ADDENDUM #2

PROJECT: Hill City WWTF Improvements

ADDENDUM NO. 2
TO
PROJECT DOCUMENTS
FOR
HILL CITY WWTF IMPROVEMENTS PROJECT
FOR
HILL CITY
HILL CITY, SOUTH DAKOTA

- Drawing Sheets
 - GEN E002 (Addendum 2)
 - PTB E102 (Addendum 2)
 - PTB E604 (Addendum 2)
 - SBR E801 (Addendum 2)
 - PB P101 (Addendum 2)
 - PB P601 (Addendum 2)
 - PB E104 (Addendum 2)
 - PB E603 (Addendum 2)
 - PB E801 (Addendum 2)
- Specifications
 - 46 41 00 Mixing Equipment – Addendum No. 2

SHEET TITLE: OVERALL NETWORK DIAGRAM			
CLIENT: CITY OF HILL CITY HILL CITY, SOUTH DAKOTA		PREPARED BY: PGM CHECKED BY: TNF APPROVED BY: JLV	
PROJECT NO: 12021-2023-005 DATE: JUNE 2026 ALT. PROJECT NO: N/A	SHEET DESIGNATOR: GEN	SHEET NO: E002

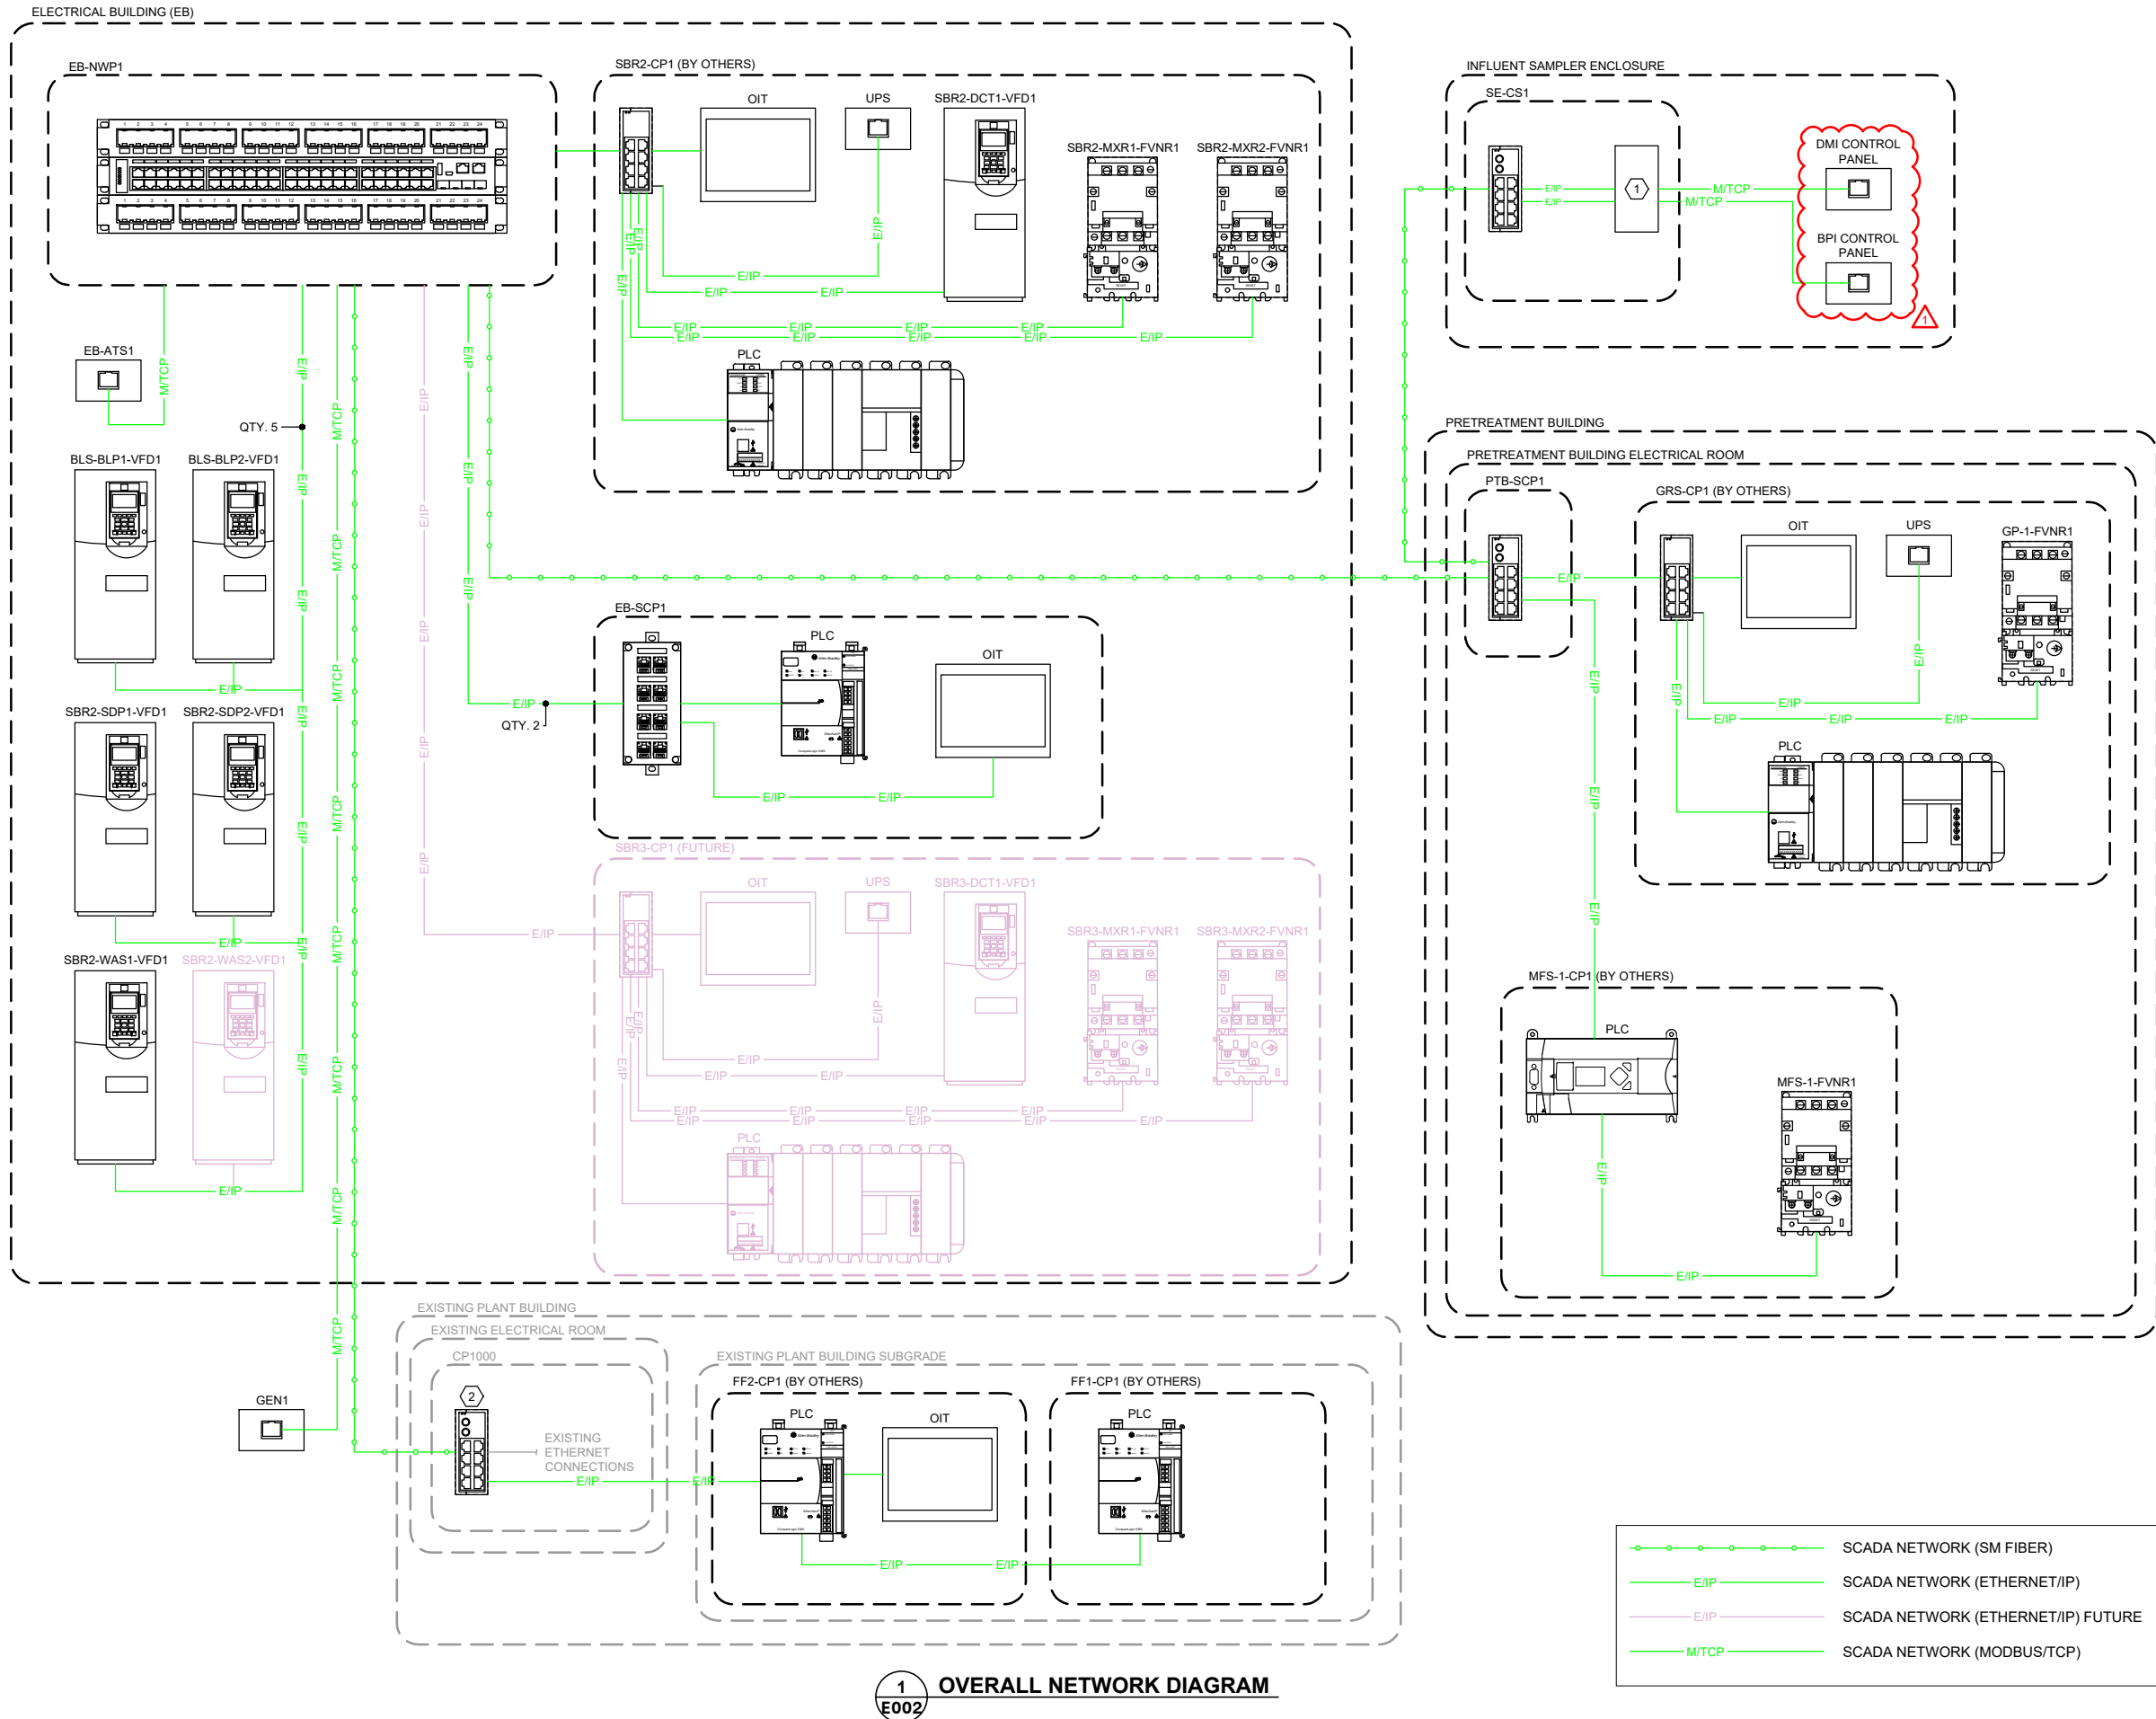
1. **Modify** label: "DMI-FIT4 CONTROL PANEL"
2. **Modify** label: "BPI-FIT4 CONTROL PANEL"

1 MAIN LEVEL PROCESS ELECTRICAL FLOOR PLAN
E102

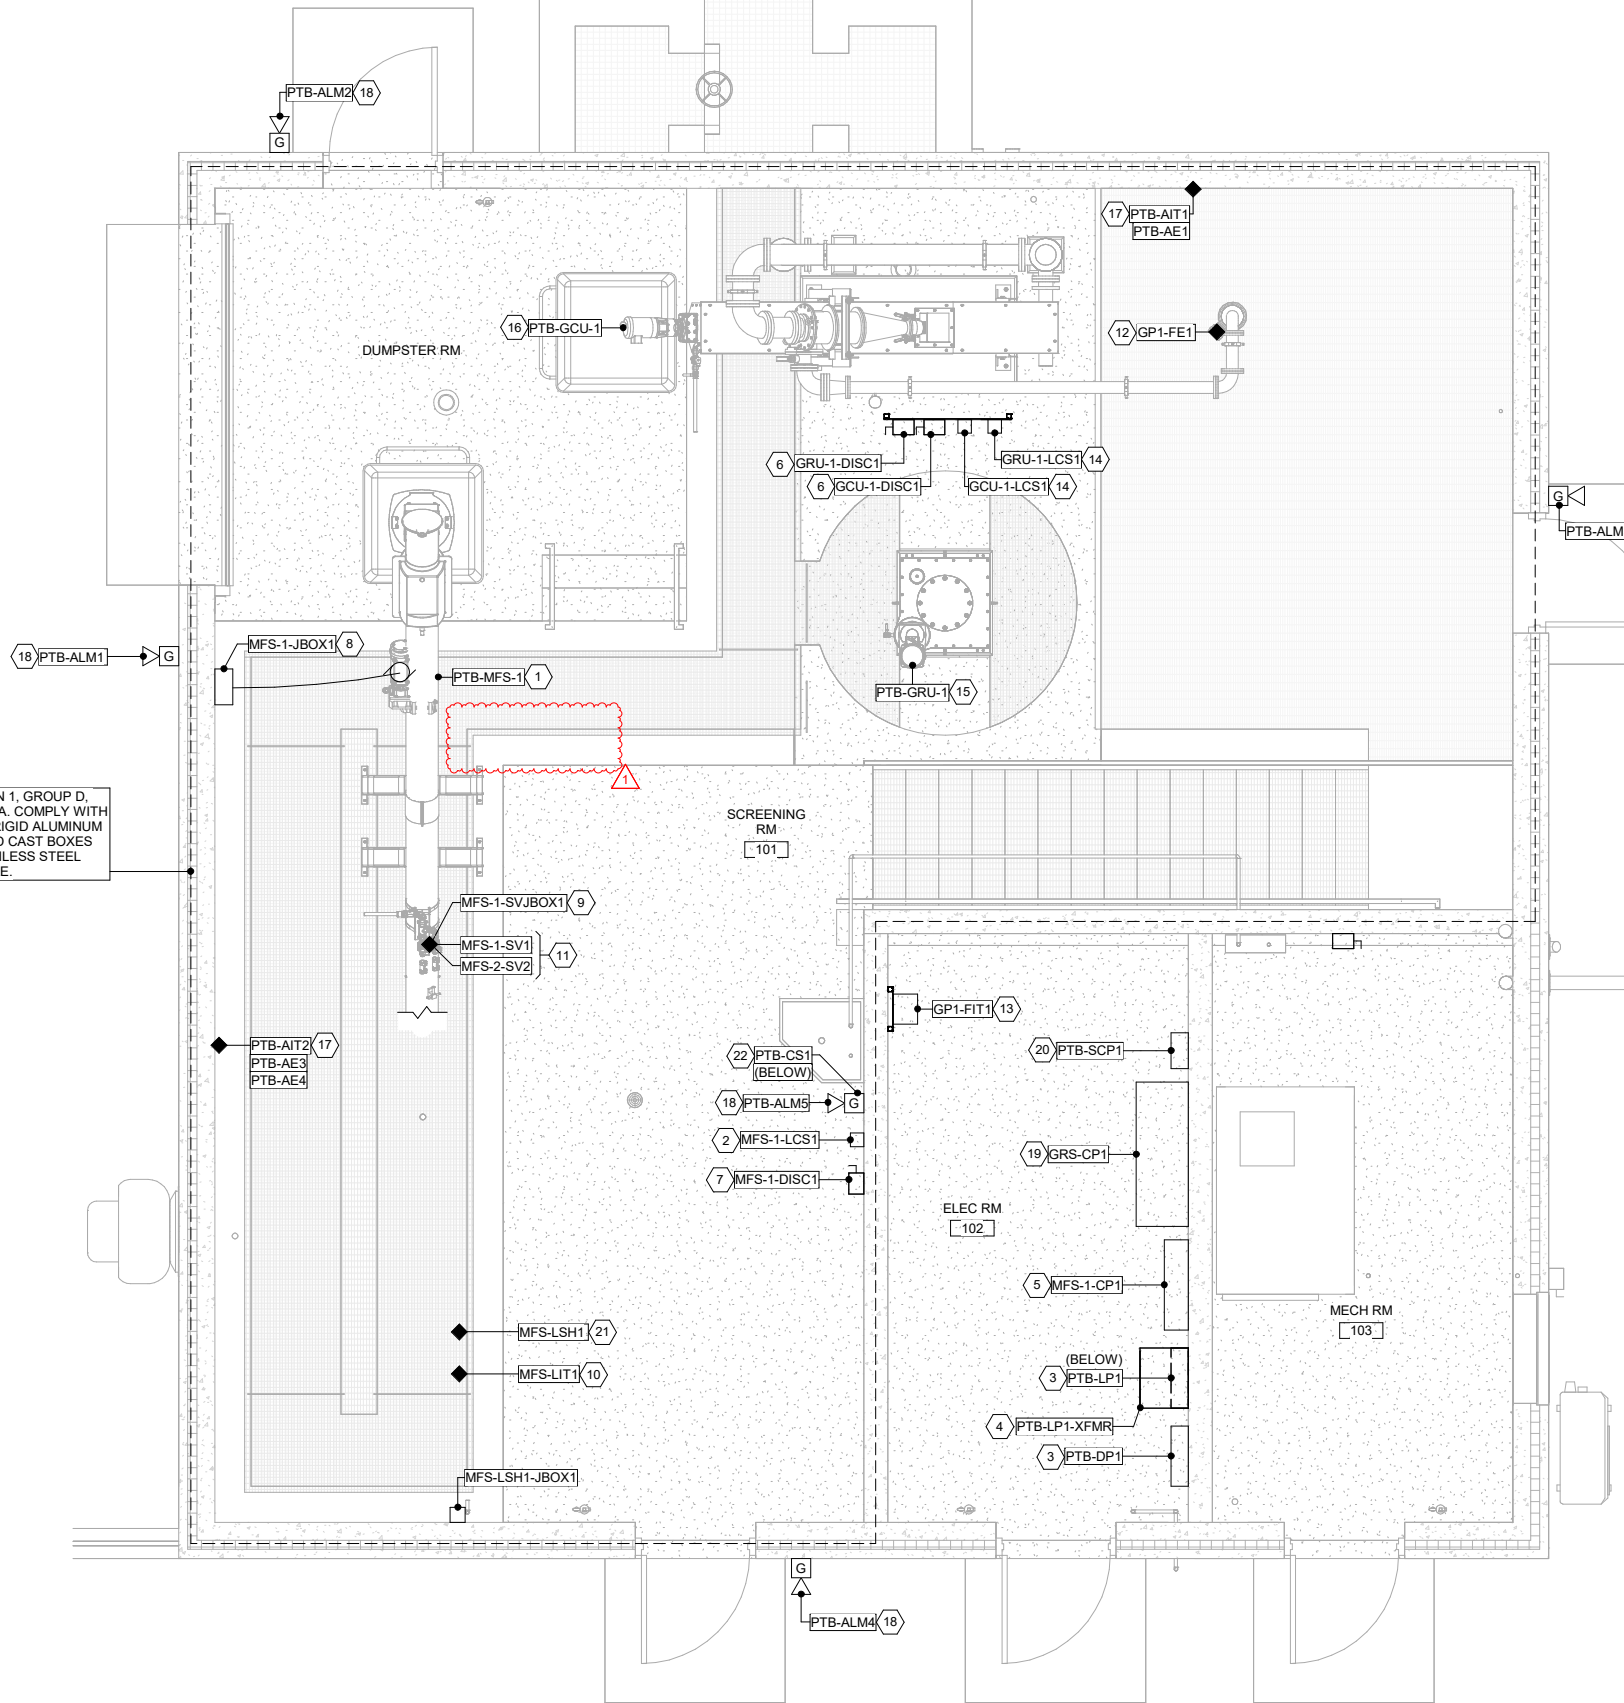
3. **Remove** MFS-LIT2 callout from floor plan.

1 SUBGRADE LEVEL - LOWER PIPING ENLARGED PLAN
P101 12' 0' 2' 4' 6' 8' 10' NORTH

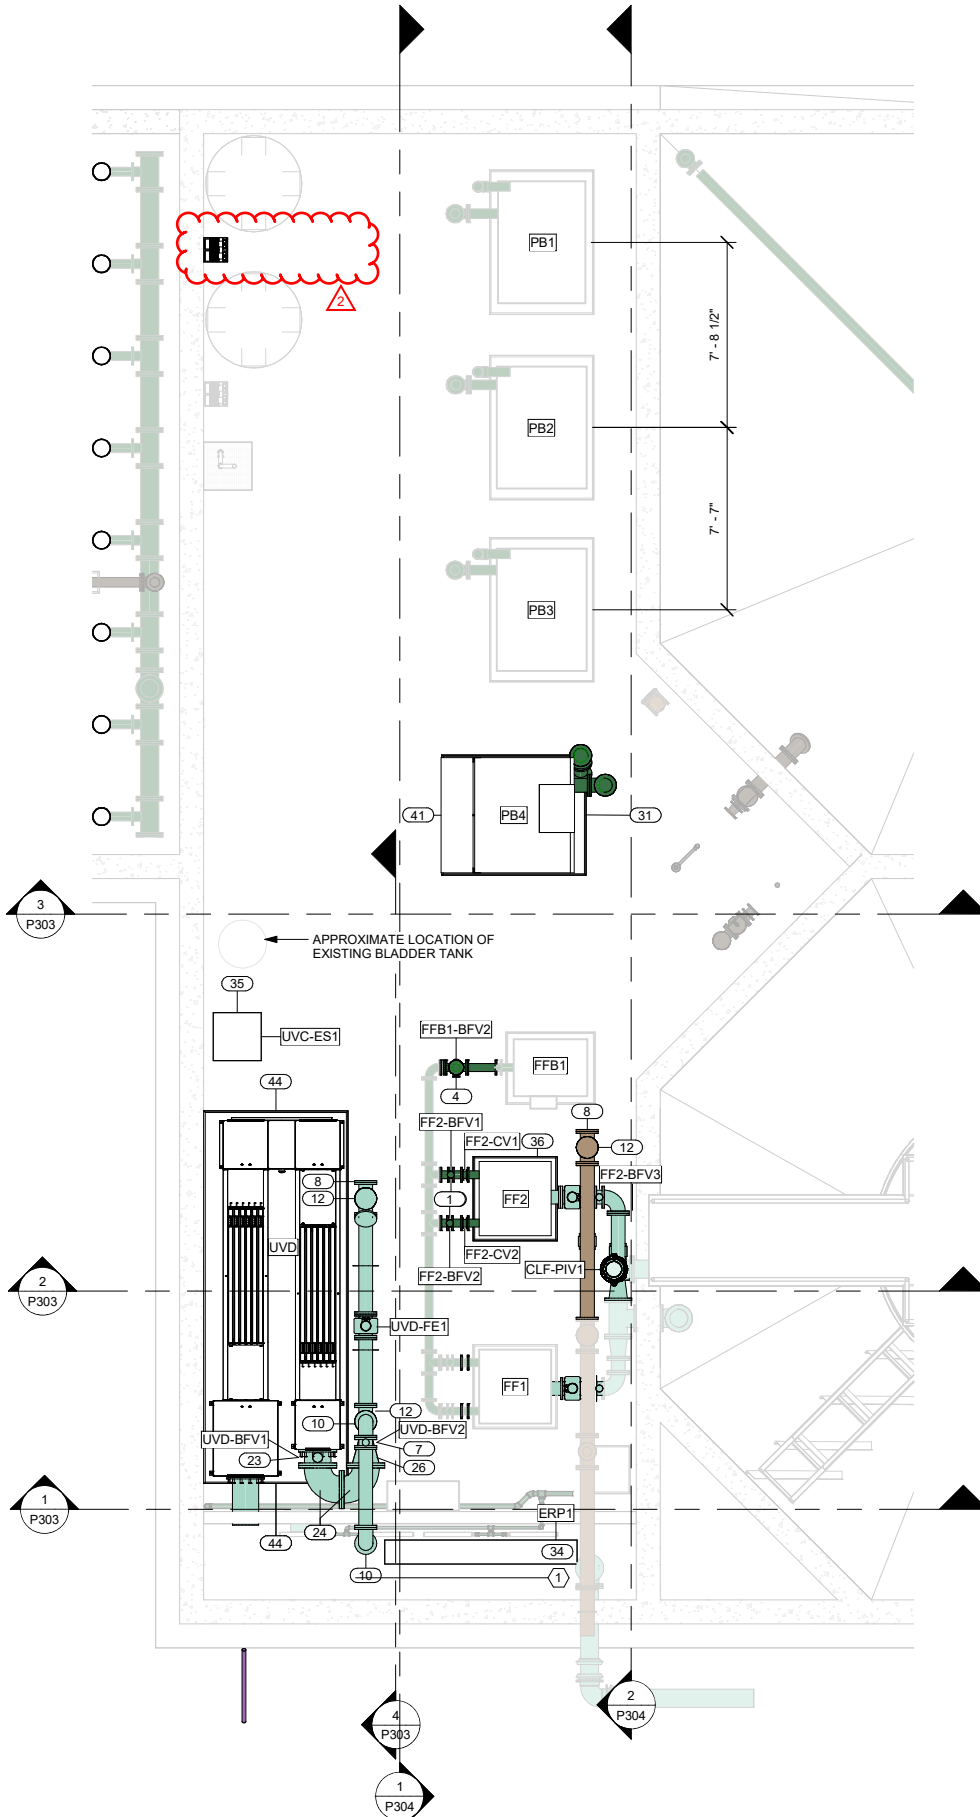
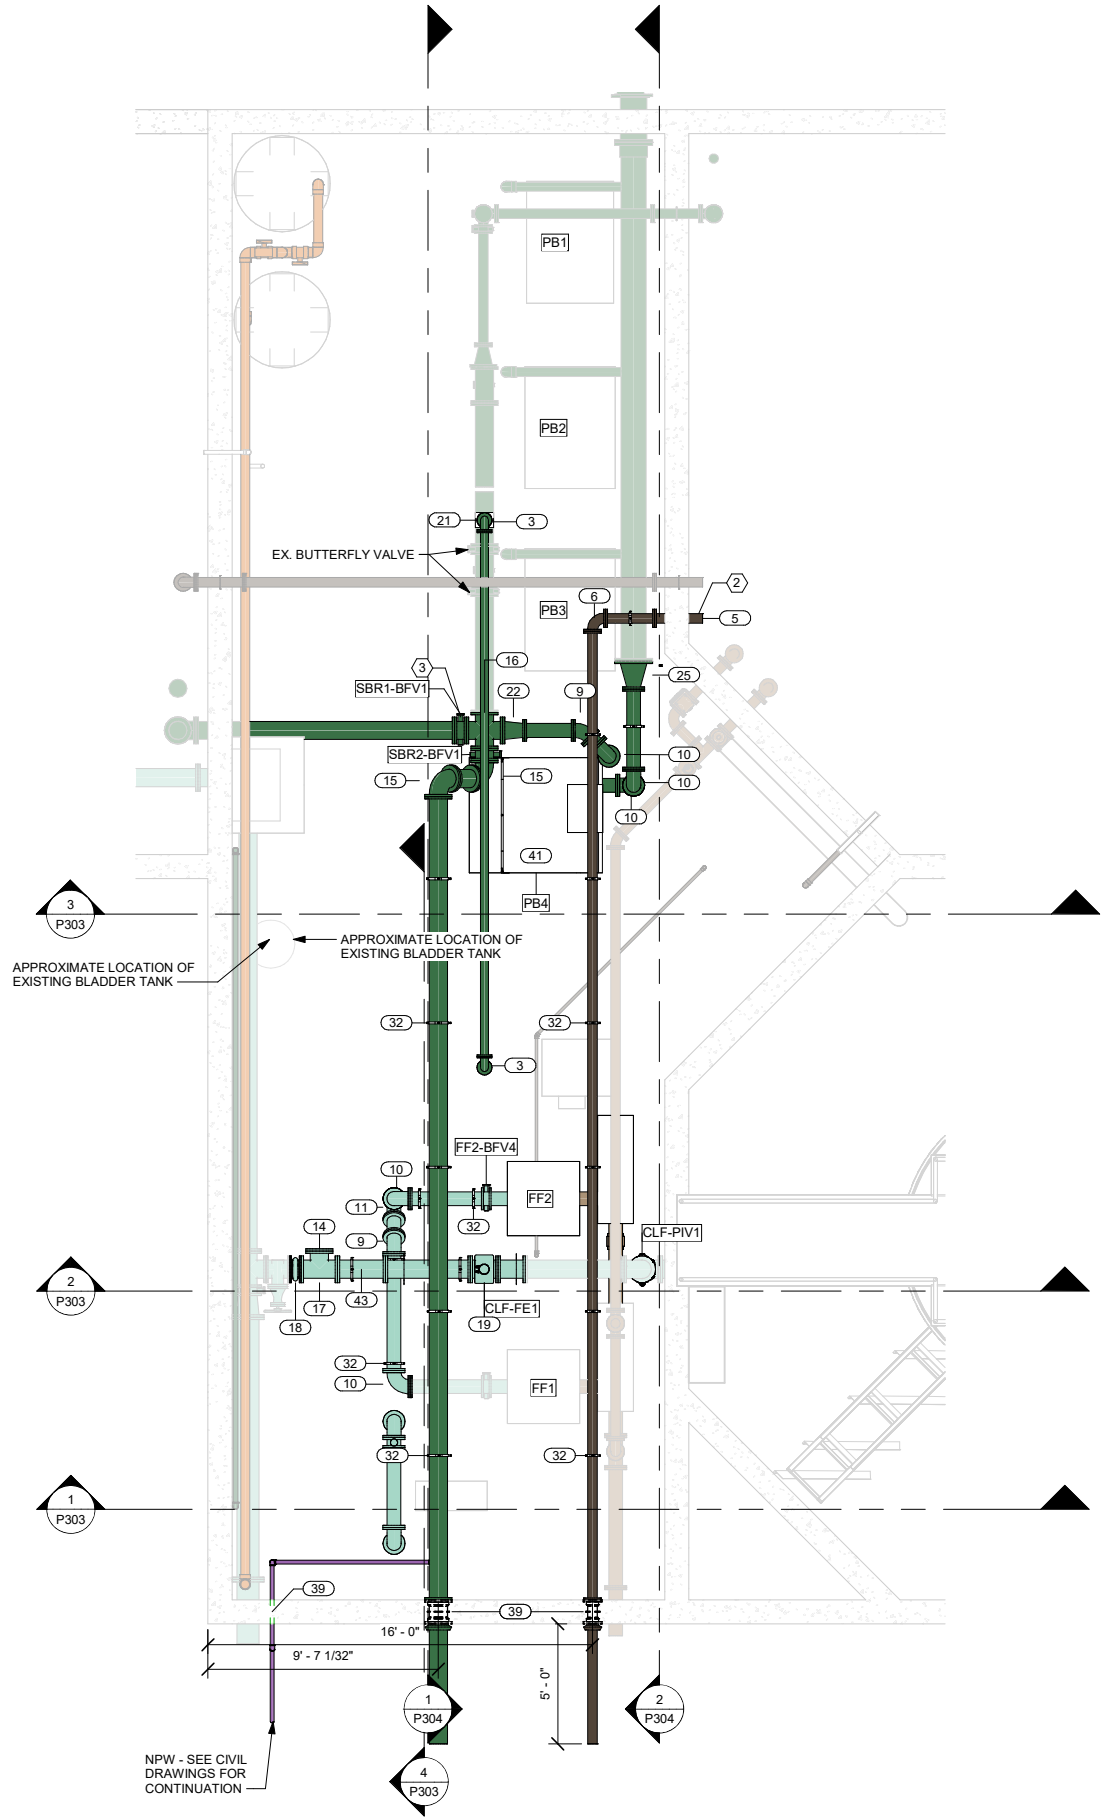
1. **Remove** Process Improvements Note 42: "~~REDUNDANT ALUM PUMP~~"
